# SAFETY RECALL BULLETIN

| SUBJECT:                           |                     |                       | No:   | SR-20-002                  |
| SEAT BELT - SAFETY RECALL CAMPAIGN |                     |                       | DATE: | May 2020                   |

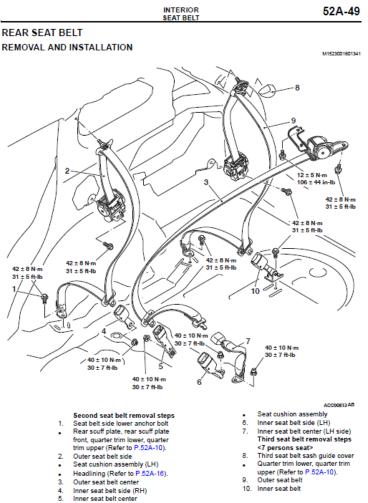
1. Turn over the belt at shoulder anchor part of right side seat belt.

2. Check direction of the seat belt guide piece (metal plating part):

OK = Inspection complete

NG = Replacement needed

• The replacement procedure will require the removal of the seat and various trim components. Please refer to the applicable service manual for removal and installation instructions.
